## Technical product information

<b>Topic</b>	Seat belt presenter – Intermittent operation
<b>Market area</b>	Russische Föderation (5RU),Australia E04 Bentley rest Asia and Australia (6E04),China 796 VW Import Comp. Ltd (Vico), Beijing (6796),Germany E02 Bentley rest Europe (6E02),Japan E03 Bentley Japan (6E03),Korea, (South) E08 Bentley South Korea (6E08),United Arab Emirates E06 Bentley Middle East and Africa (6E06),United Kingdom E01 Bentley UK (6E01),United States E05 Bentley USA and rest America (6E05)
<b>Brand</b>	Bentley
<b>Transaction No.</b>	2068643/1
<b>Level</b>	EH
<b>Status</b>	Released for publishing
<b>Release date</b>	18-Nov-2022

### Continental GT and GTC

Figure 2

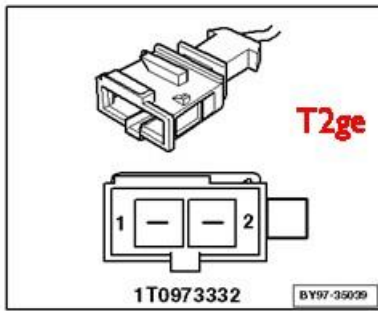
- Disconnect connector T2ge at the occupancy sensor (E31 Drivers, E32 Passengers). The 2 way connection can be identified by its blue connector housing located under the seat frame adjacent to the inboard seat runner (see Figure 2)
